CITY OF SACRAMENTO
CALIFORNIA

SPECIAL PERMIT MODIFICATION
(P92-278)

APPLICATION: Planning Director's Modification of a Special Permit to allow construction of a 3,803 square foot veterinary hospital on 1.2± partially developed acres in the Rural Estates (RE 1/4) zone.

LOCATION: 7615 Sheldon Road

EXHIBIT - A SITE PLAN

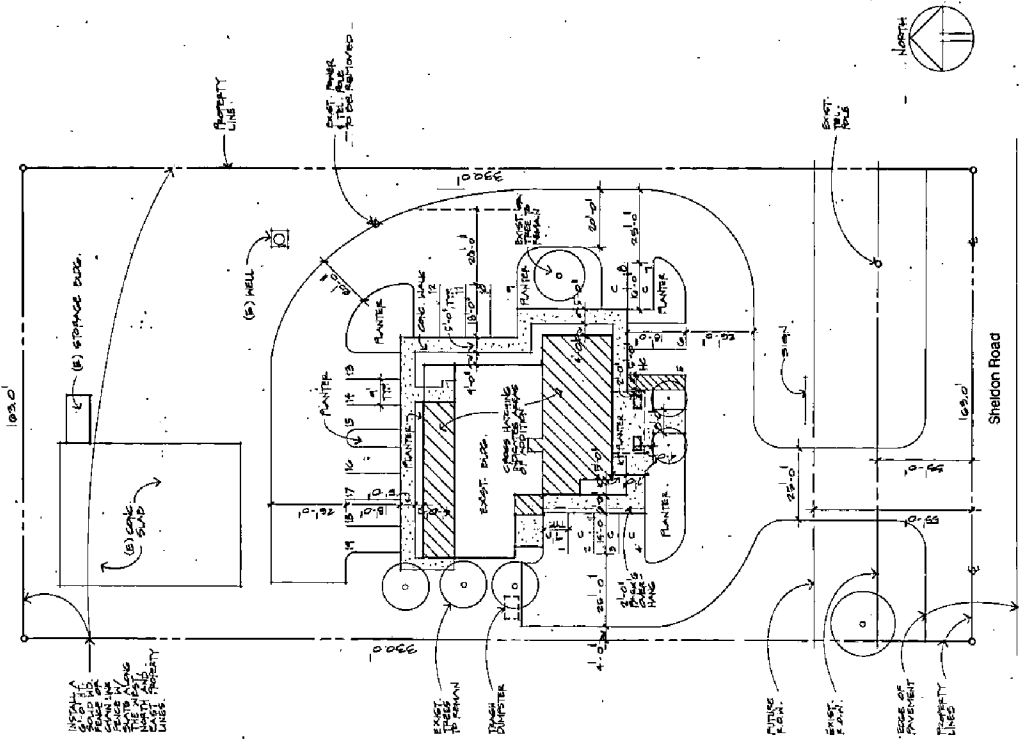
The submitted site plan places the building in the center of the site, with parking around the perimeter of the building. The applicant has revised his site plan to incorporate the parking and maneuvering areas required by the City. The County reviewed a special permit to reduce the parking requirements. The City, however, views veterinary hospitals as a medical use requiring one parking space for each 200 square feet. The 3,803 square foot veterinary hospital requires 19 parking spaces. The site plan indicates 19 spaces provided on site. It is unclear from the applicant's site plan how much of the area of the lot which is not used for parking is landscaped. The applicant shall submit a landscape plan for review and approval of the Planning Director prior to the issuance of Building Permits. The landscape plan shall indicate the required fifty percent tree shading of the parking and driveway areas, as well as all other landscape areas. The front setback area should be landscaped with a combination of trees, shrubs and groundcover to shield the driveway from view from the street. All portions of the property which are not landscaped or paved shall be barricaded from entry by a six inch concrete curb, fence, or bollards. No storage or parking is allowed on unpaved surfaces.

The City of Sacramento Zoning Ordinance requires that a six foot solid masonry wall be located along property lines which abut residential uses or zones. The site plan indicates a wood fence or chain link with slats. The site plan will need to be modified to indicate a solid masonry wall along the east, west, and northern property lines. The wall shall be located outside of the required front setback area.

5. The site plan shall indicate a six foot ^{wood fence} ~~high solid masonry wall~~ along the north, east and west property lines. The wall shall not be located within the required front setback area.

EXHIBIT - B
ELEVATIONS

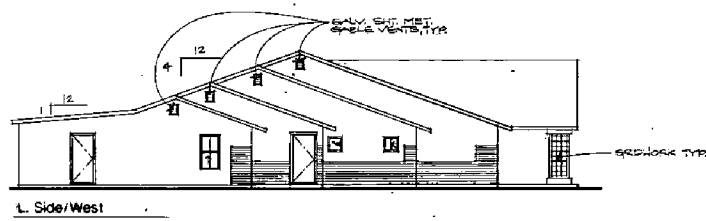
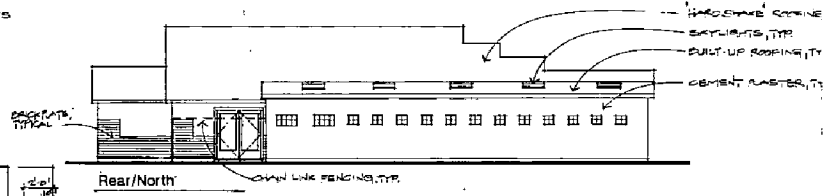
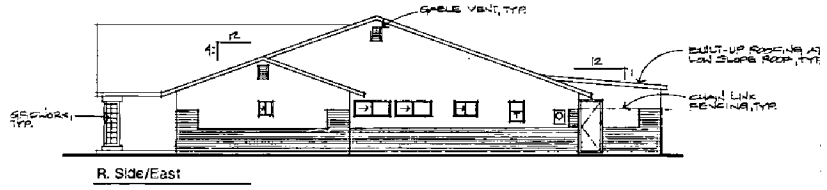
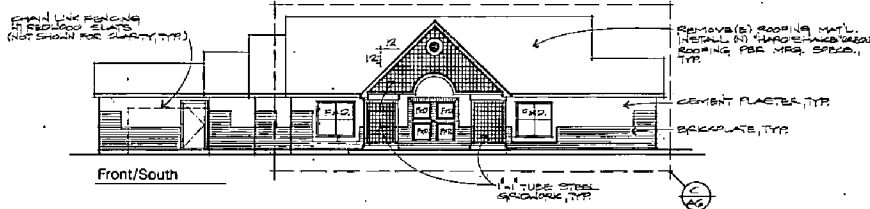
The proposed building is a single story building. The elevations indicate the exterior materials to be cement plaster with brick trim at the base. There is also steel gridwork which accents the main entrance. Staff has no objection to the proposed design of the building. The roof material is indicated to be "Hardshake" or something similar. If composition shingle roofing is proposed, it shall be a minimum 25 year rated laminated dimensional composition shingle.

6. The design of the structure shall be as per the submitted plans. If composition shingle roofing is proposed, it shall be a minimum 25 year rated laminated dimensional composition shingle.

Sign Elevation
SCALE 3/8" = 1'-0"

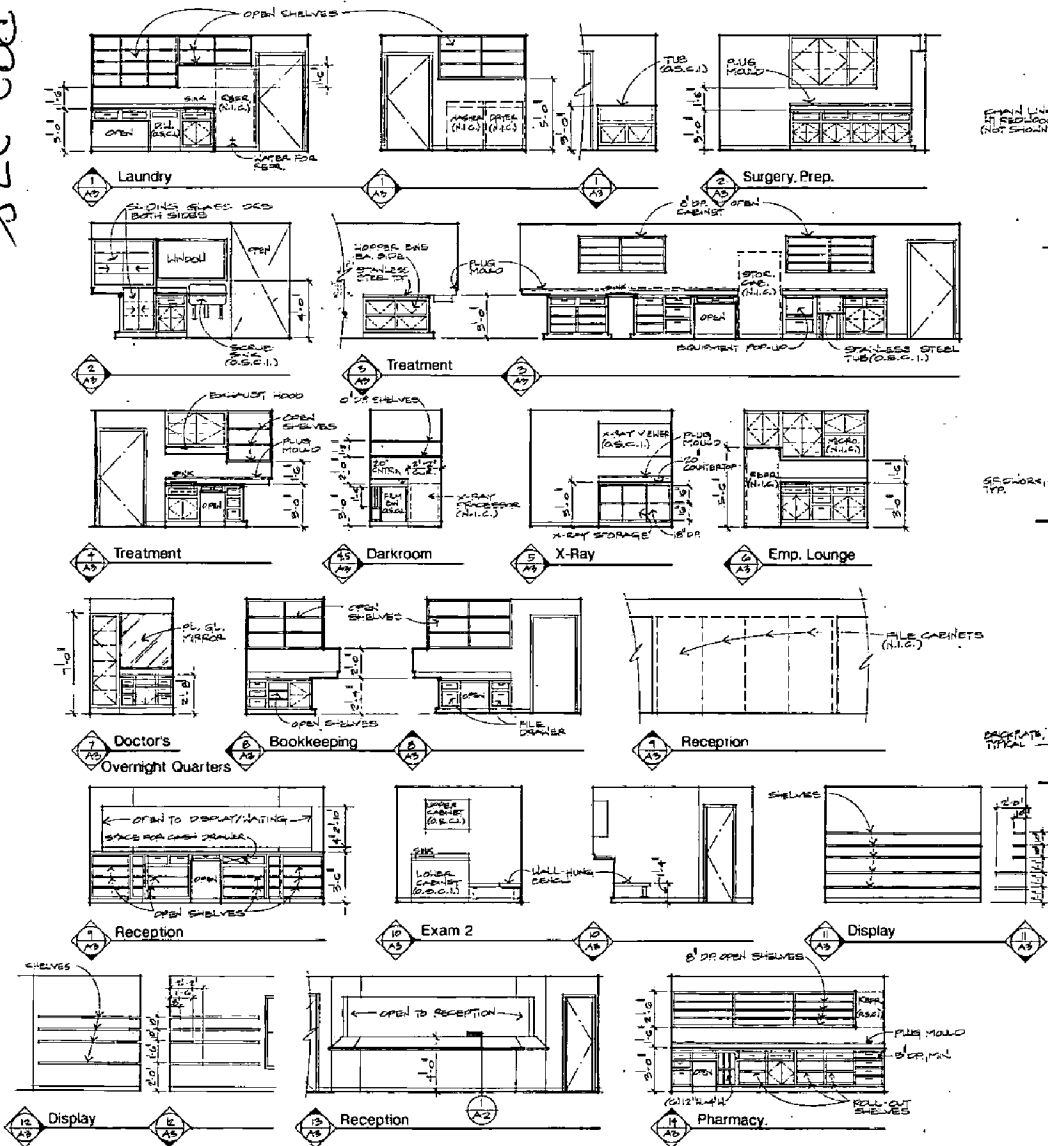
The applicant has also indicated the proposed signage for the site. Staff has no objection to the location or design of the proposed monument sign. The Sign Ordinance, however, limits signage to 16 square feet for non-residential uses within a residential zone. The applicant's proposal consists of a 30 square foot (15' x 2') sign. The applicant should redesign the sign prior to the issuance of Sign Permits.

7. The applicant shall submit a revised sign prior to the issuance of Sign Permits. The sign shall be a monument sign not exceeding 16 square feet in area.

TREE EXHIBIT

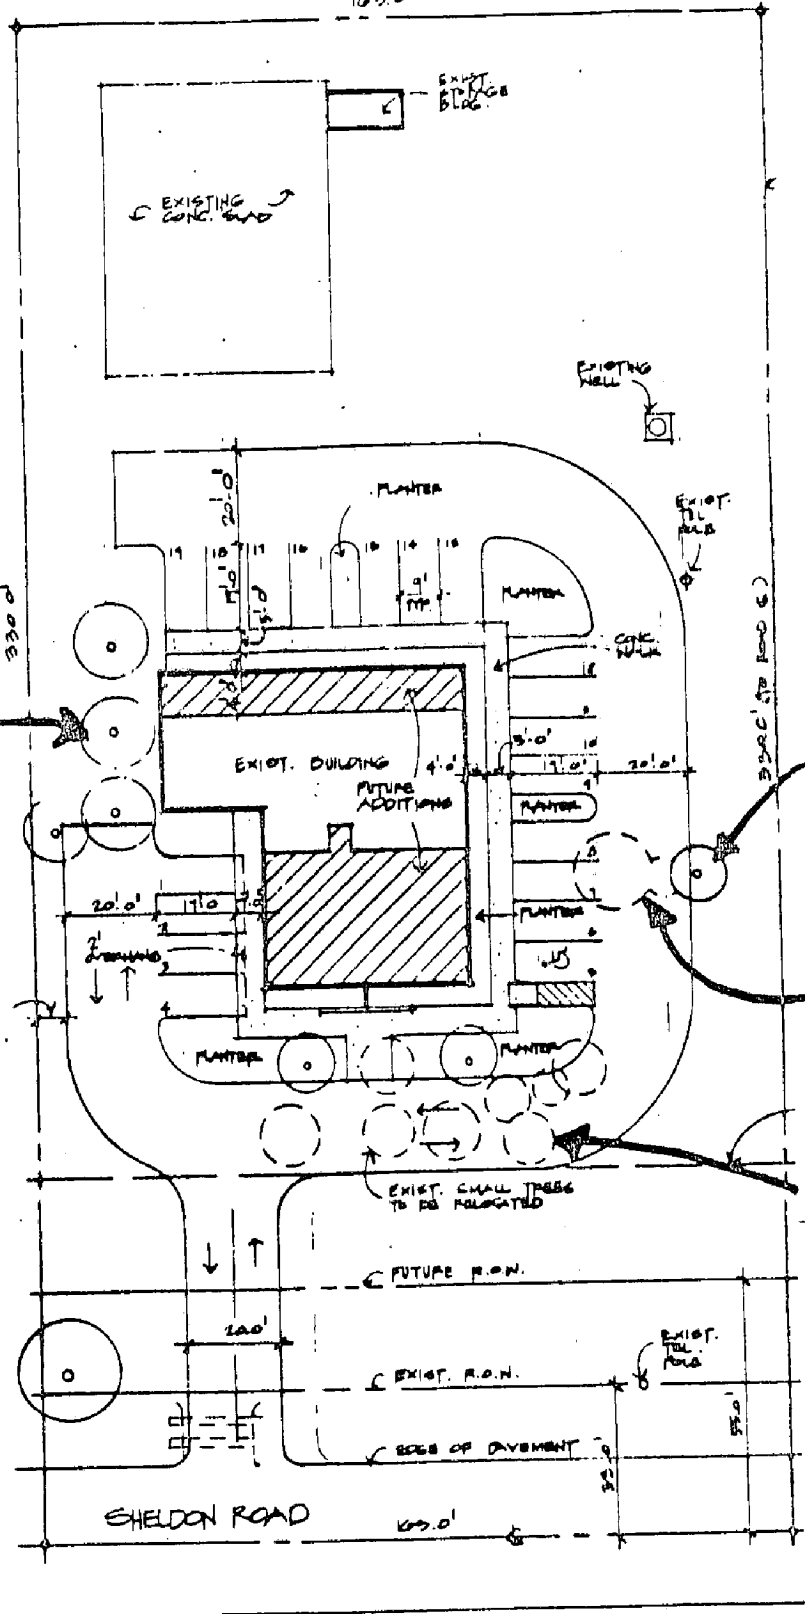
- A. To compensate for the removal of the 12 inch dbh oak tree the applicant shall plant twelve 15-gallon native oak trees (either valley oak/Quercus lobata or interior live oak/Q. wislizenii). Prior to the physical modification of the project site, a Replacement Oak Tree Planting Plan shall be prepared by a certified arborist or other professional tree expert and shall be submitted to the Planning Director for review and approval. The Replacement Oak Tree Planting Plan shall include at the minimum the following elements:

a. To compensate for the removal of the 12 inch dbh oak tree the applicant shall plant twelve 15-gallon native oak trees (either valley oak/Quercus lobata or interior live oak/Q. wislizenii). Prior to the physical modification of the project site, a Replacement Oak Tree Planting Plan shall be prepared by a certified arborist or other professional tree expert and shall be submitted to the Planning Director for review and approval. The Replacement Oak Tree Planting Plan shall include at the minimum the following elements:
